M A Y 2 8 , 2 0 2 1

RE: Plan Review Response for Red Cloud Addition

Sheet C3-20

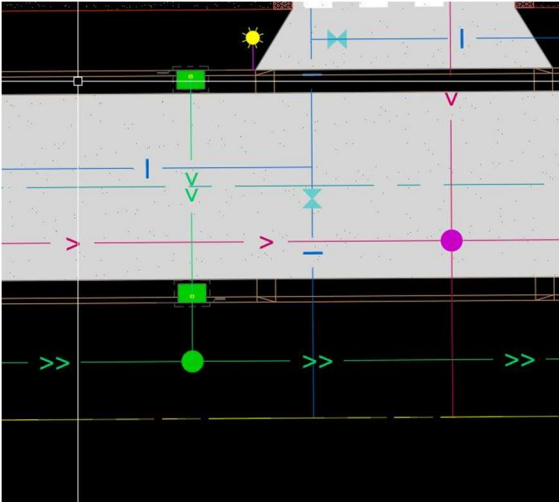
The utilities in Hagar Street are not to City of La Crosse Standards. The Sanitary main should be in the center of the street with the water main located 8-feet north (minimum) and the storm sewer should be located 8-feet south (minimum) of the sanitary sewer. Also, the storm sewer needs to have its own main with manholes (not from catch basin to catch basin as shown). Manholes are required for access and proper cleaning of the lines.

Engineer's Response: Standard spacing of utilities was adjusted to this section of Hagar Street to accommodate the requested narrow street width while still maintaining required separation of storm and sanitary from watermain. We propose placing the manholes and storm main in the center of the future sidewalk running on the south side of Hagar Street as shown below. The 8' spacing is achieved as proposed below.
